Subject: Application ID: 2008-0023

# Jeanie Bourke - 165 Park Ave. Fitzpatrick Restrooms

# **Building Permit Application for the Fitzpatrick Stadium Toilet Building**

RE: Fitzpatrick Restrooms, 165 Park Avenue

# SITE PLAN REVIEW APPROVAL

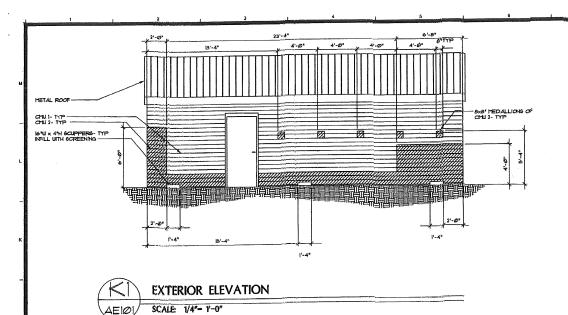
- 1. That the site plan be revised reflecting a building configuration that is parallel to Decring Avenue.
- That the building elevation be revised to reflect a hip roof.
- 3. Applicant has agreed to discuss with Planning Staff a more appropriate color concrete block scheme, which shall be reviewed and approved by Planning Staff.
